Urgent Field Safety Notice

SBN-CPS-2018-002

cobas e 801 syringe plunger issue

Product Name	cobas® 8000 modular analyzer series cobas e 801 module
Affected Instrument Part GMMI / Part No	PLUNGER (798-3203)
Instrument/System Affected	cobas e 801 module (GMMI 07682913001) from serial numbers 1601-01 to 18E6-10
SW Version	Not applicable
Type of Action	Field Safety Corrective Action (FSCA)

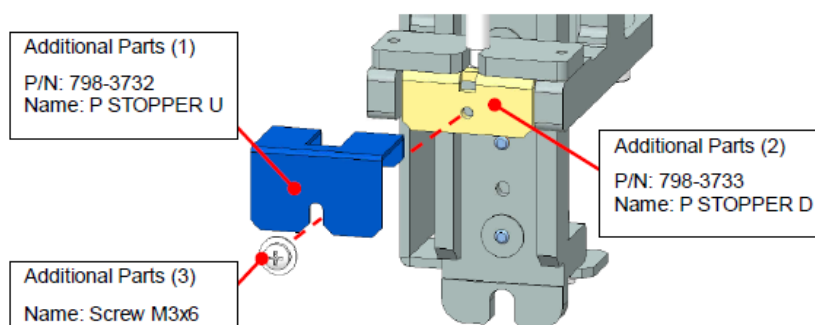
Depending on how the seal pieces are assembled it is possible that the plunger is mounted in a tilted position which applies mechanical stress to the plunger. In the worst case scenario during the **cobas e 801** initialization steps when the largest strokes happen, the plunger may crack leading to an impaired syringe function.

A mandatory installation of a syringe plunger guide for the R1, R2 and PW syringes is required for **cobas e 801** modules in the field, from serial numbers 1601-01 to 18E6-10, illustrated below:

Hardware modification kits (above seen additional parts) are already available in our warehouse.

The installation of the kit requires few minutes, if the instrument is available in [Standby] mode. The kit assures the correct positioning and movement of the referred syringe plungers and thus prevents the issue.
